Sub: Joint Meeting of the Standing Committee on Power System Planning of
Southern Region and Western Region - Minutes of the meeting

Minutes for Joint Meeting of Standing Committee on Power System Planning in Southern Region and Western Region **held on 20 April, 2015 at NRPC, Katwaria Saria, New Delhi**

2.0 Modification proposed by PGCIL in Raigarh-Pugalur- Kerala 6000 MW HVDC System

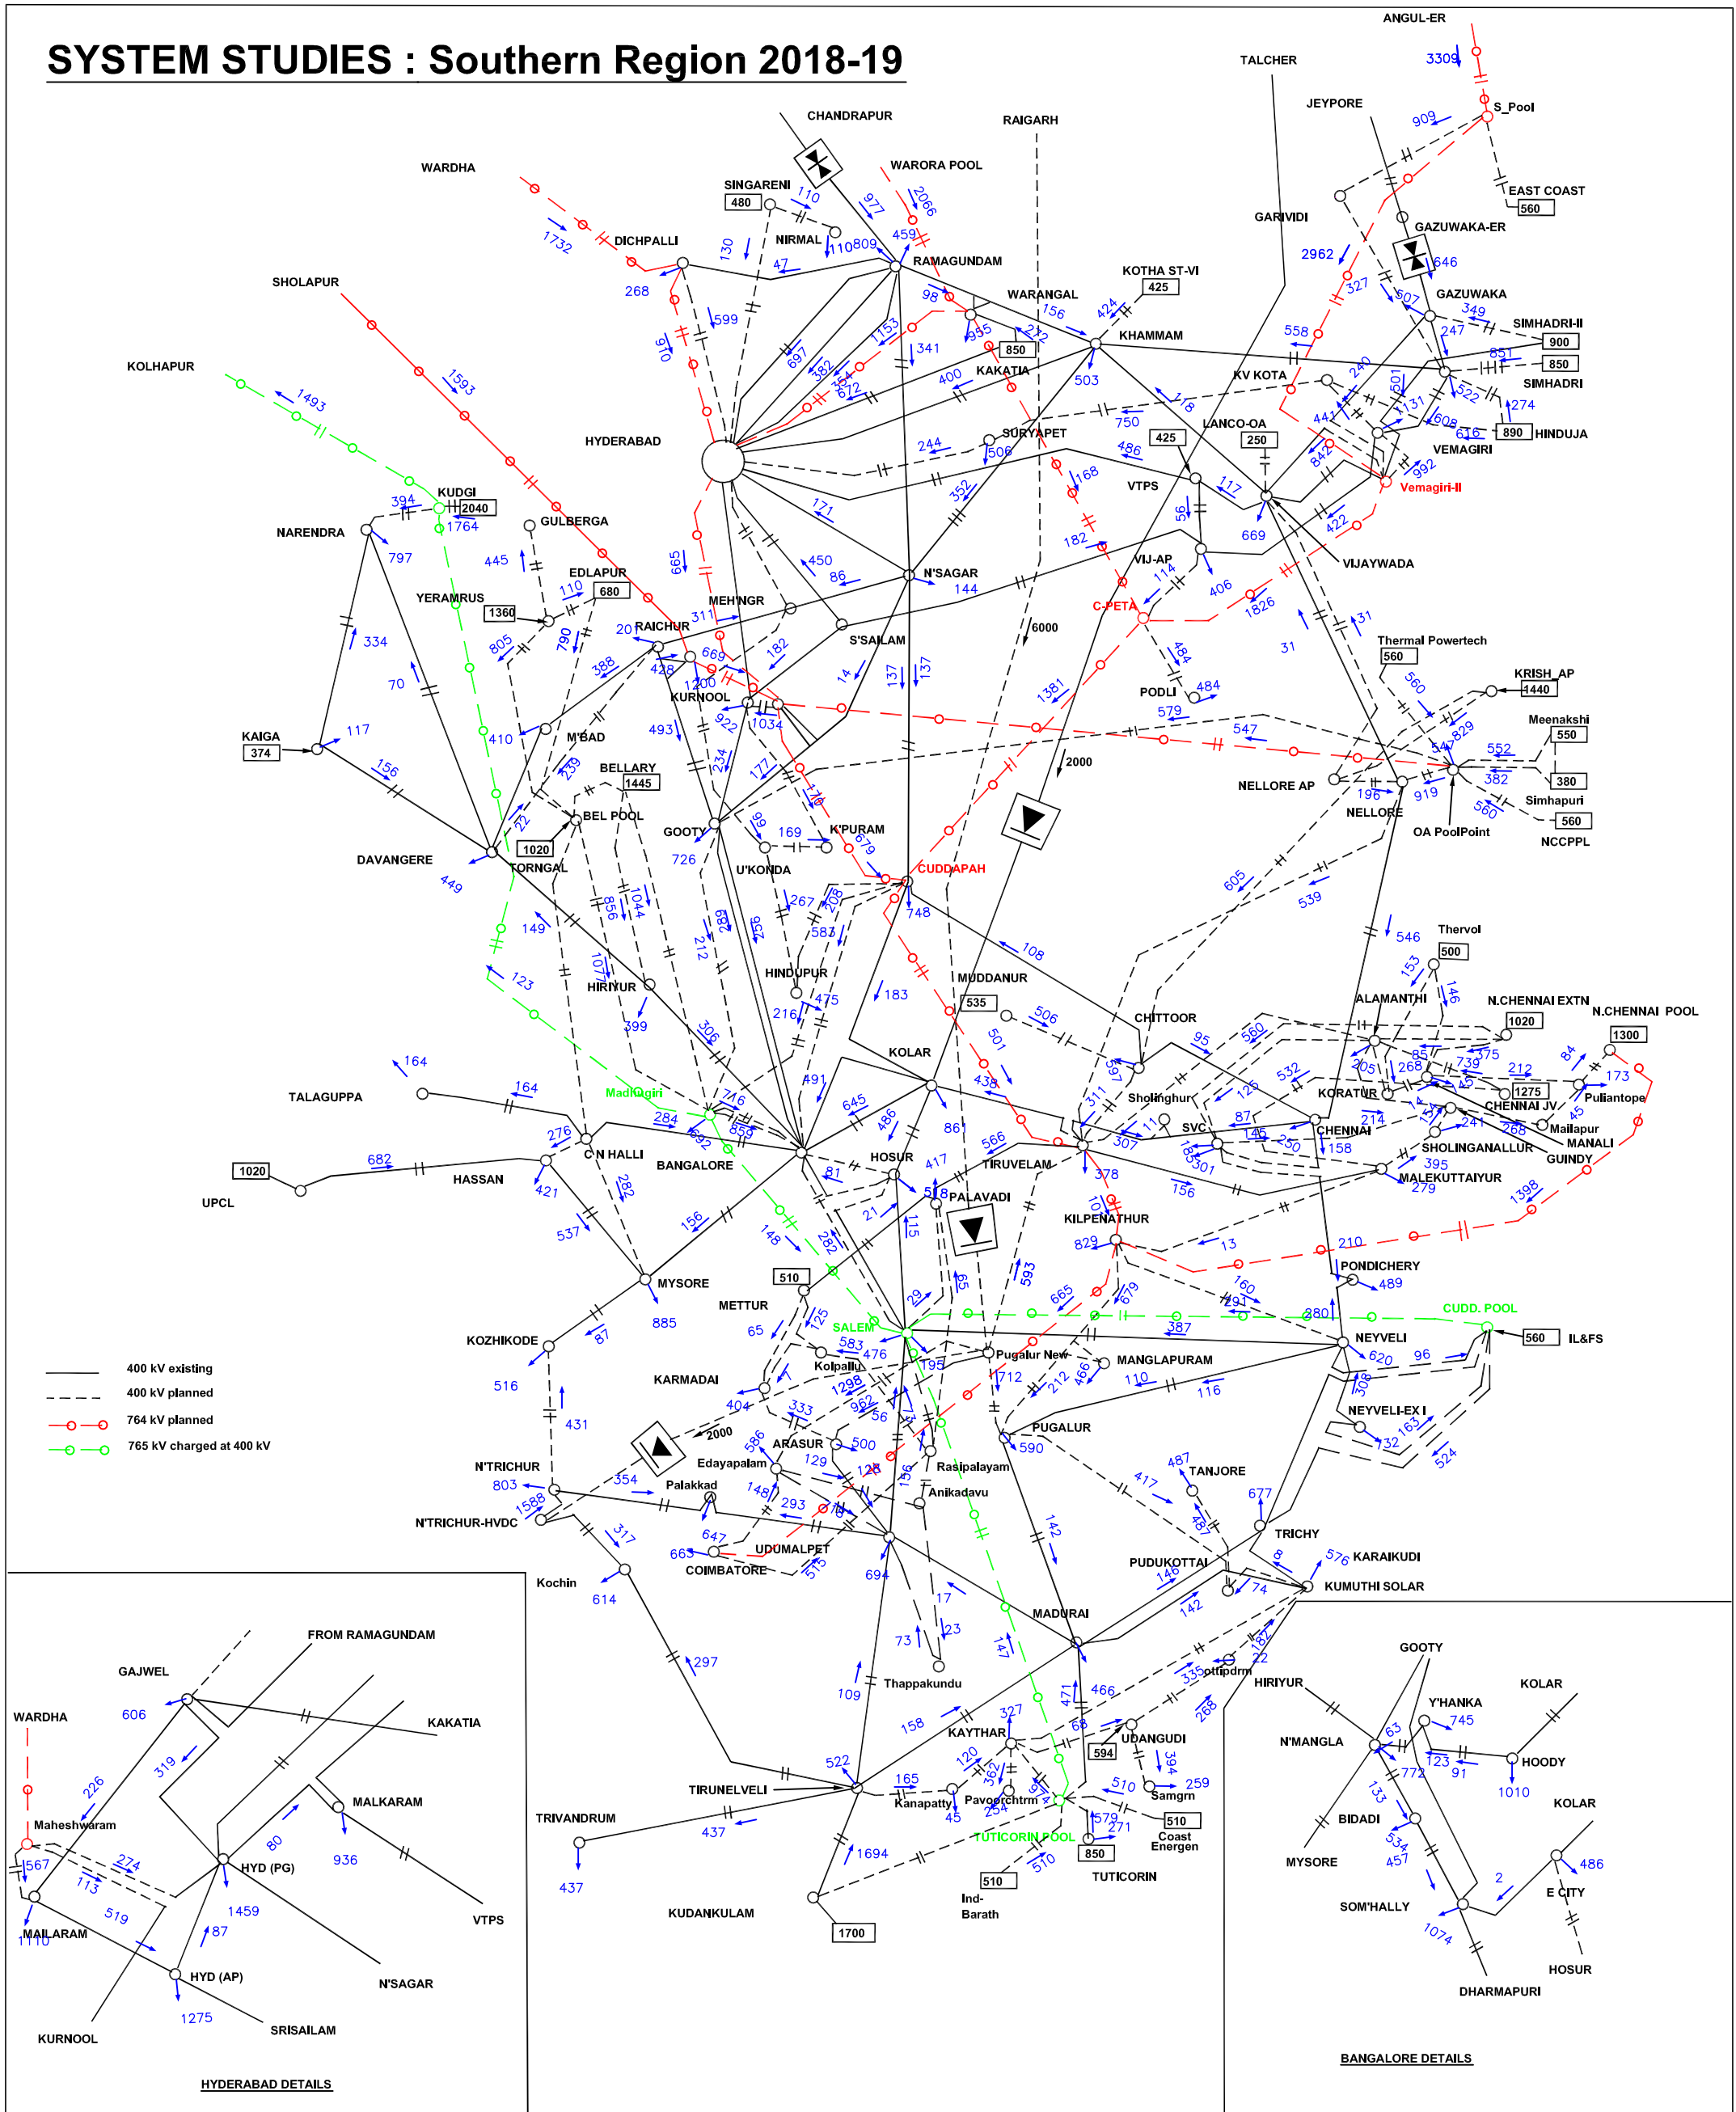
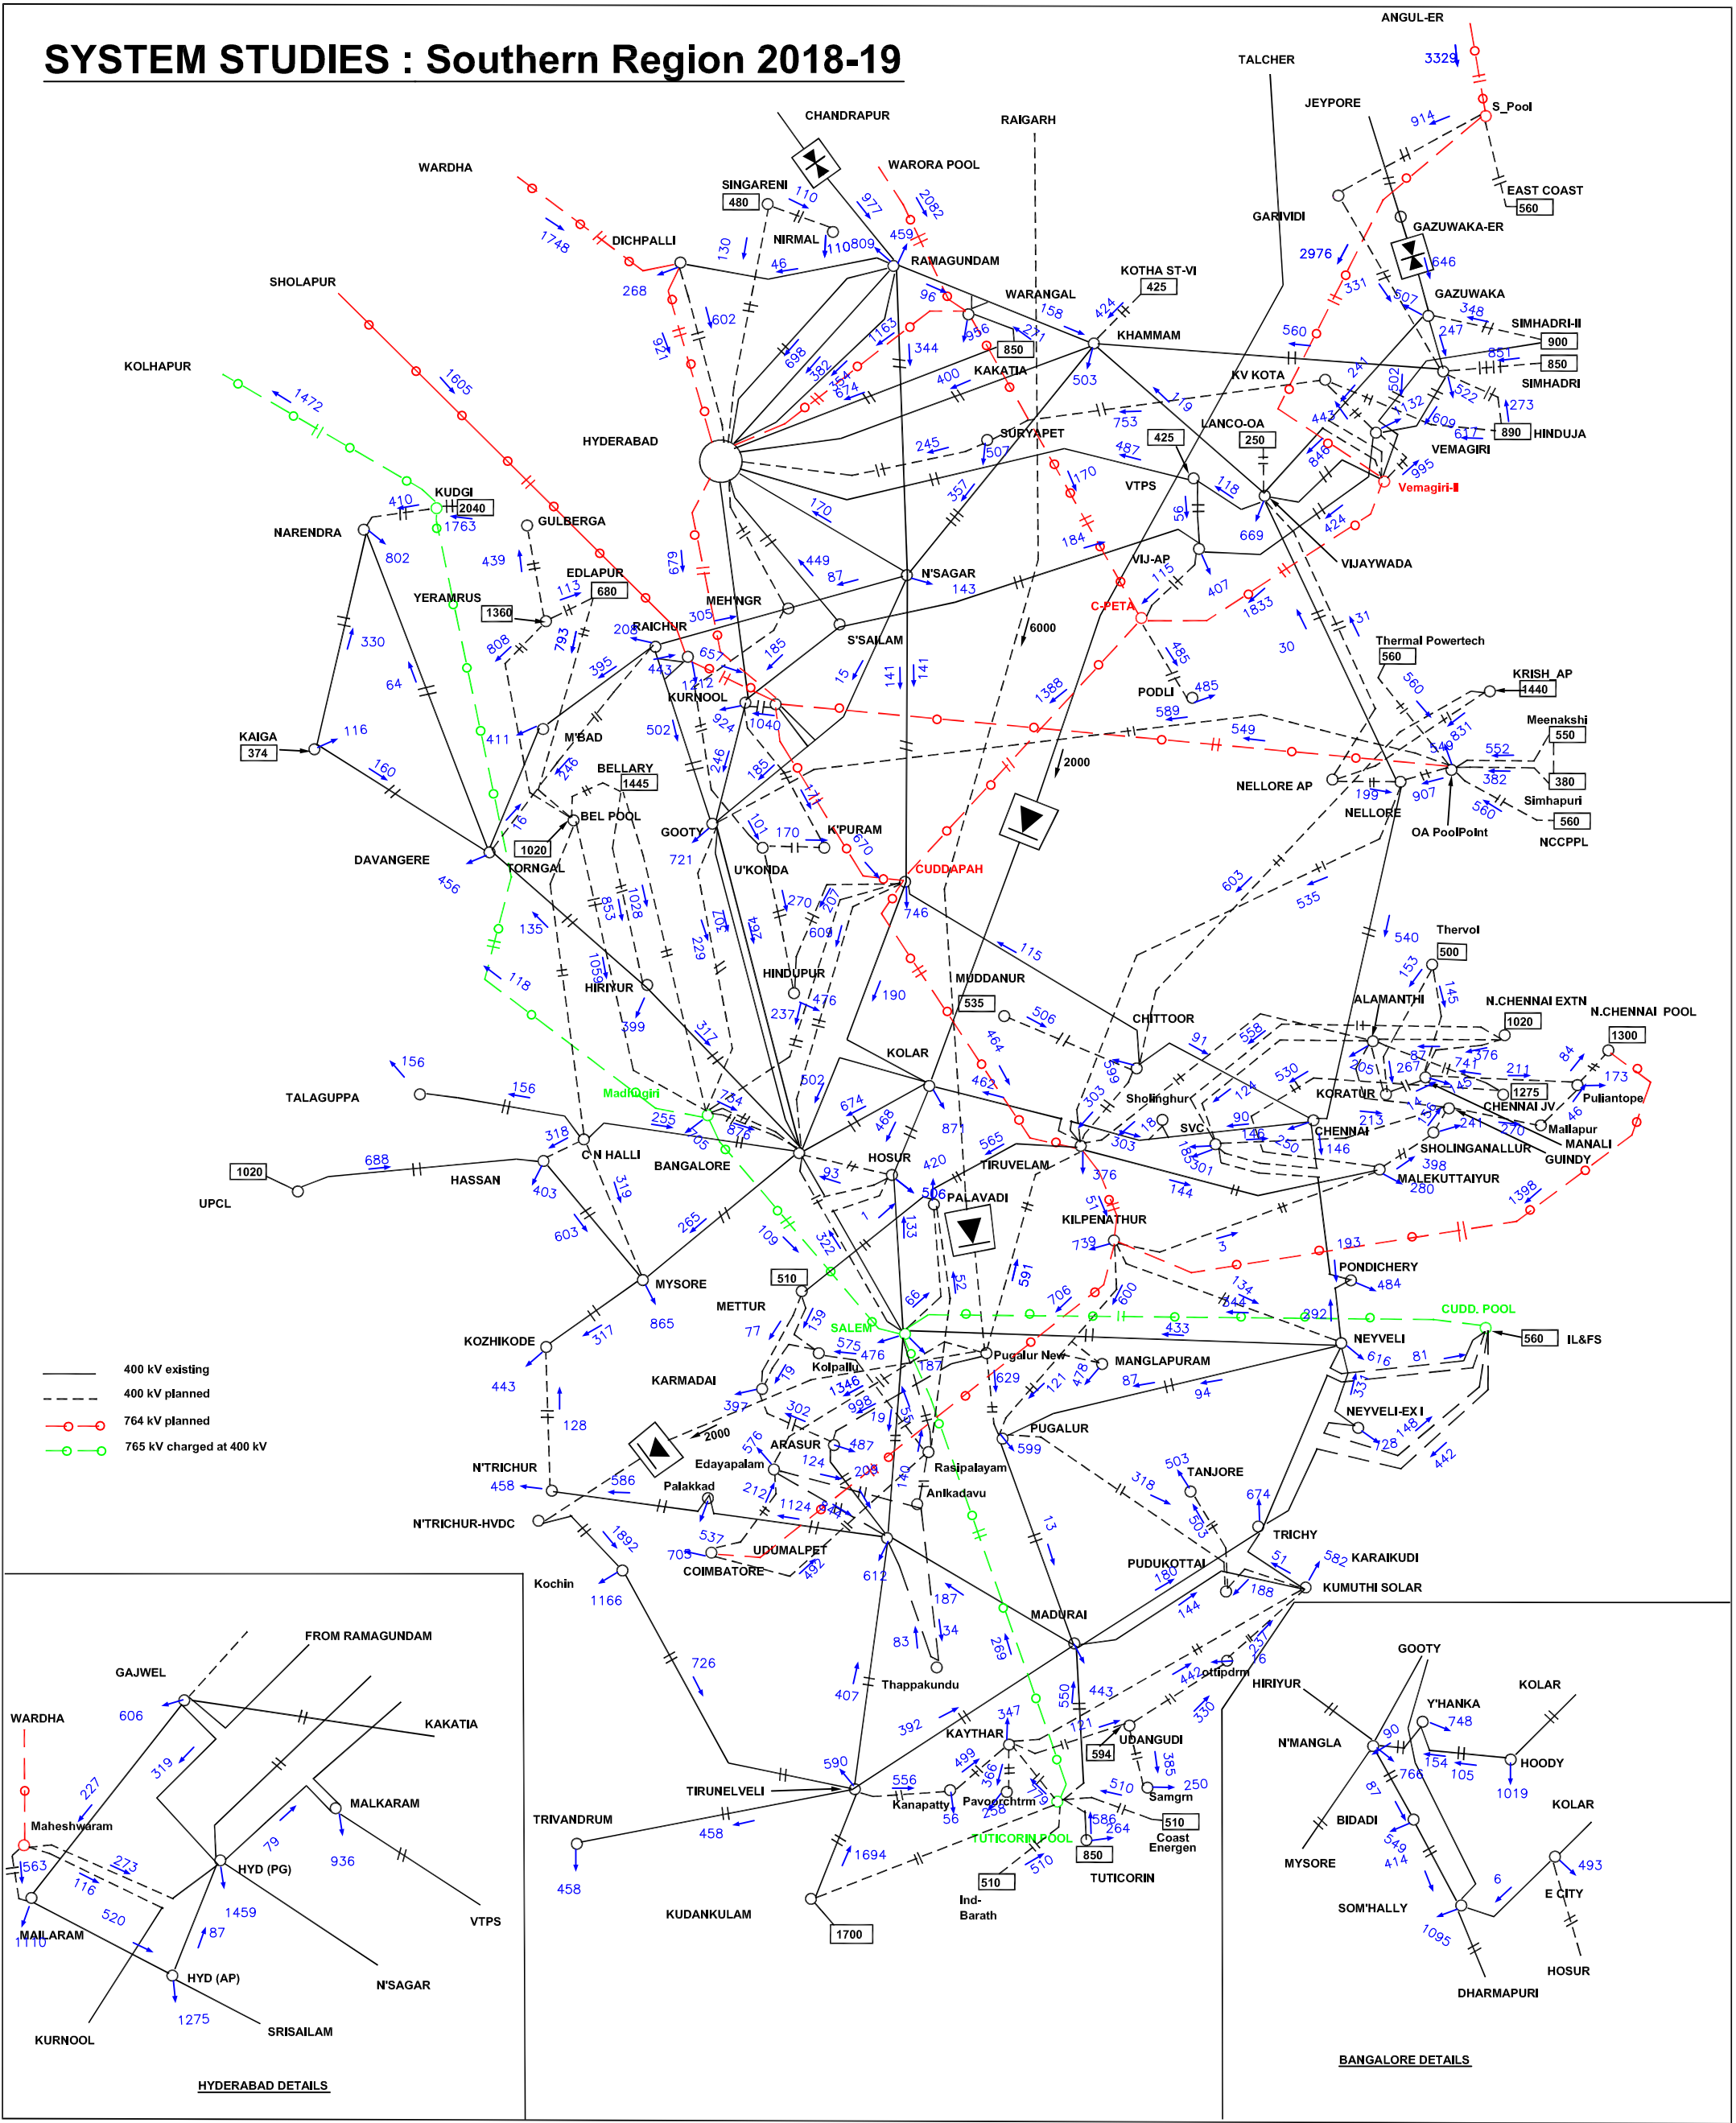
- n. **System Studies for** inter connection of North Trichur HVDC Station with 400kV system in Kerala. Indicative transmission system strengthening required in Kerala state network, so that 2000 MW gets absorbed in the Kerala without overloading/congestion of the 220kV or 110kV network in Kerala. It is requested that corresponding loadflow and SLD file may also be sent to CEA.

(n):System Studies for inter connection of North Trichur HVDC Station with 400kV system in Kerala. Indicative transmission system strengthening required in Kerala state network, so that 2000 MW gets absorbed in the Kerala without overloading/congestion of the 220kV or 110kV network in Kerala. It is requested that corresponding load flow and SLD file may also be sent to CEA.

Reply- Studies has been carried out with 2000MW injection at North Trichur. Injection is through LILO of Cochin-North Trichur 400kV D/c (Quad line). The total load of Kerala is about 5425MW which is met by self-generation of 1360MW and import of 4065MW. The details of tie line flows are shown in Exhibit-I. From the Exhibit-I it is seen that Edamon-Tirunellveli is loaded to 363MW per circuit. Under one pole outage the loading on the line increases to 376MW on each circuit. For above load-generation balance in the absence of proposed HVDC bipole, loading on Edamon-Tirunellveli is 390MW per circuit.

Load flow simulations are plotted in **Exhibit-II & III**. Under (n-1) condition, no constraint is envisaged on line loadings around North Trichur. However, transformers at Cochin and North Trichur gets loaded to 694MW (630MW) and 780MW (630MVA) even under base case. Transformers augmentation as proposed during 37th SCM needs to be taken up with matching 220kV augmentation. Under (n-1-1) contingency if both North Trichur-North Trichur (HVDC) are taken under outage then the entire power would flow towards Kochin and about 1285MW is dropped through transformers and remaining power flows towards Tirunelveli. Strengthening of 220kV to be taken up at Kochin.

In case-1 the 220kV network around Kochin area gets highly over loaded. For Exhibit-2b power flow on HVDC is restricted to 600 MW and load of Kerala to 3850MW to bring the transformer loading on Cochin within the limits (610MW).
